P−16253−1
E0526

PARTY'S NAME	AXIS SOLUTIONS PVT. LTD., AHMEDABAD
PARTY'S DRAWING No.	AS PER AutoCAD DRAWING
ALLOY & TEMPER	HE9 WP
DESCRIPTION	HEAT SINK SECTION

DRAWING No.	SECTION No.
P−16253−1	−
E0526	E0526(ISSUE−2

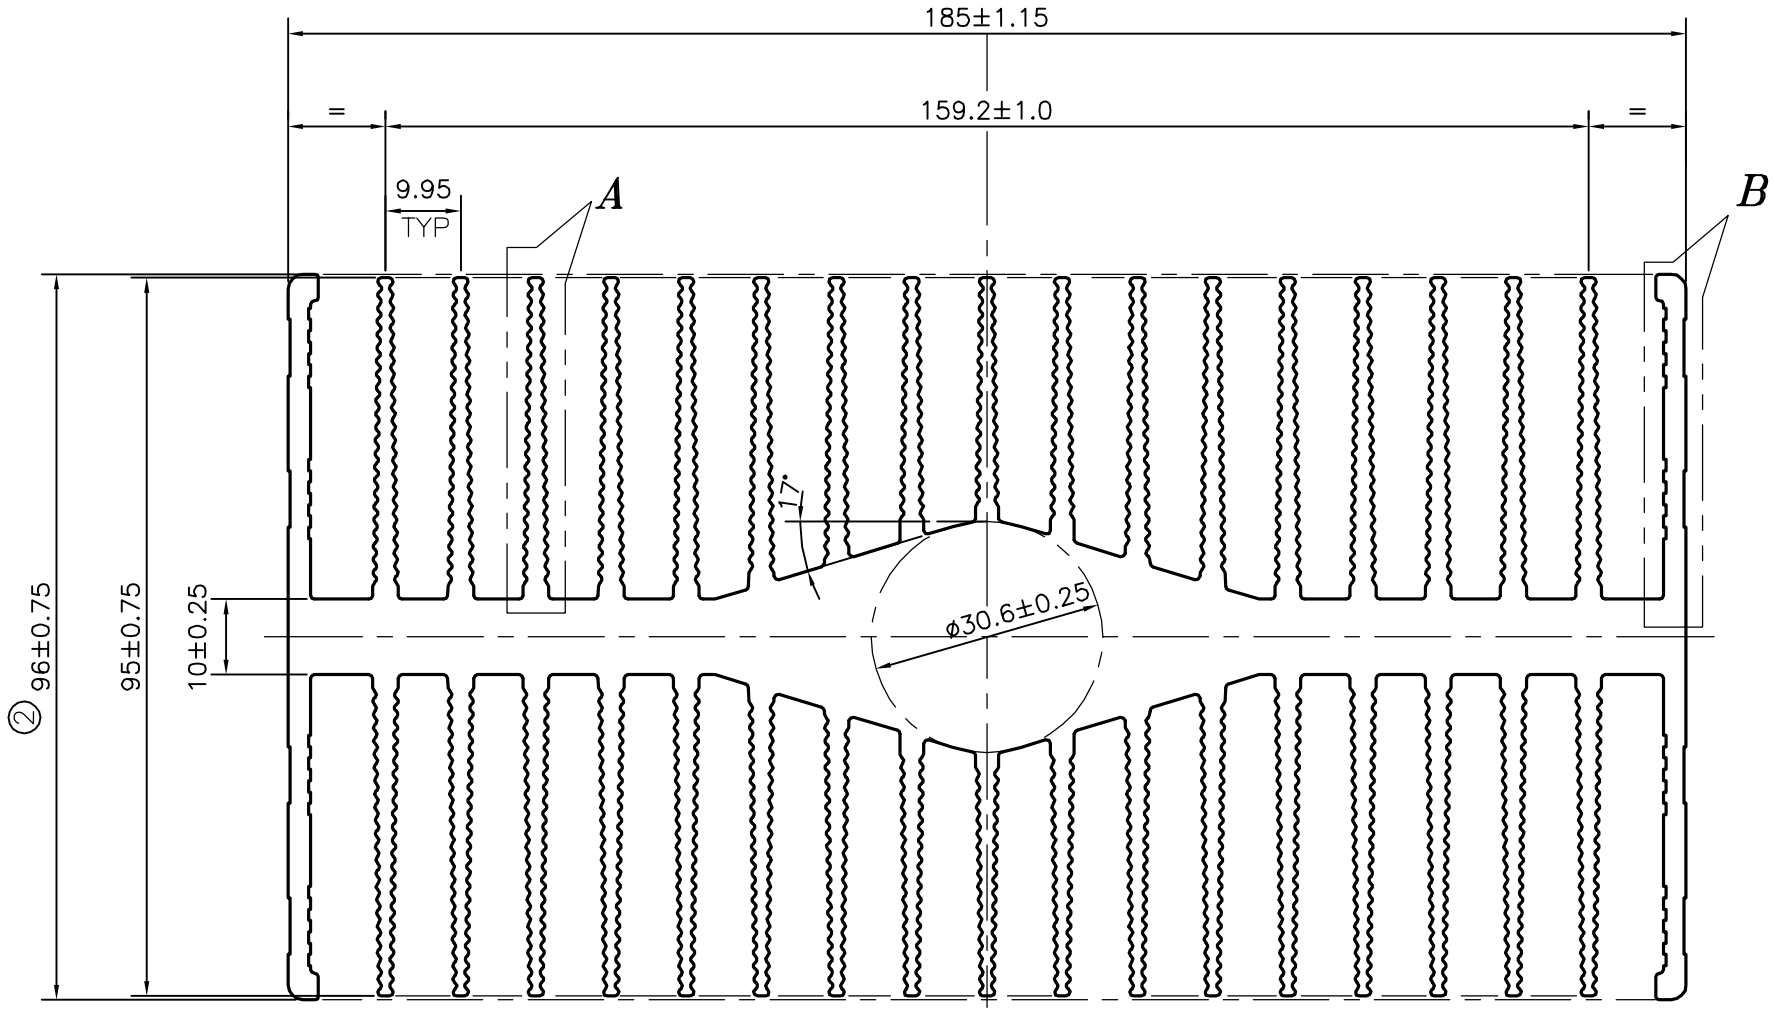
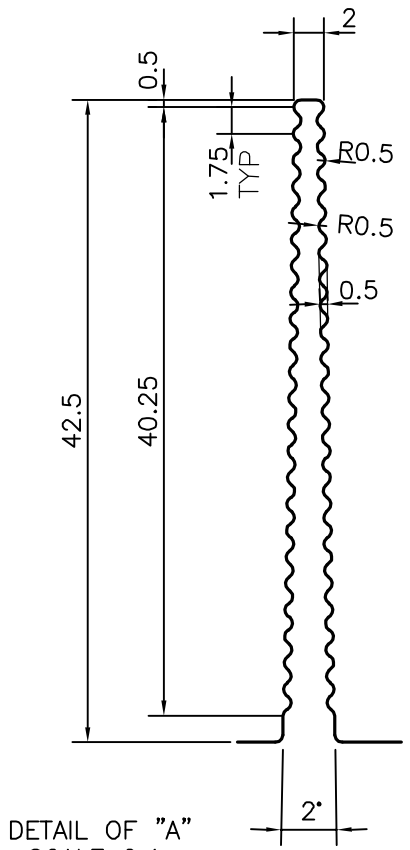
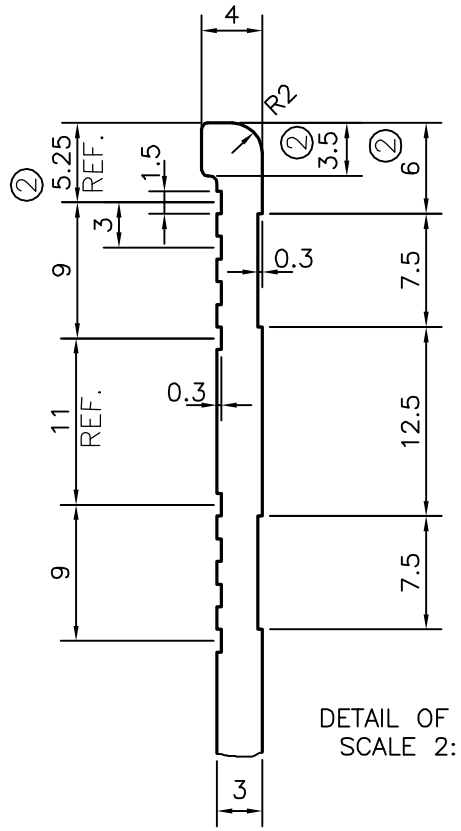
SIDE FINS HEIGHT INCREASED FROM 95 TO 96 mm
DIMENSION CHANGED FROM 4.75 TO 5.25 mm, 3mm TO 3.5 mm & 5.5 TO 6.0 mm
WEIGHT ALSO CHANGED FROM 16.637 Kg/M TO 16.658 Kg/M
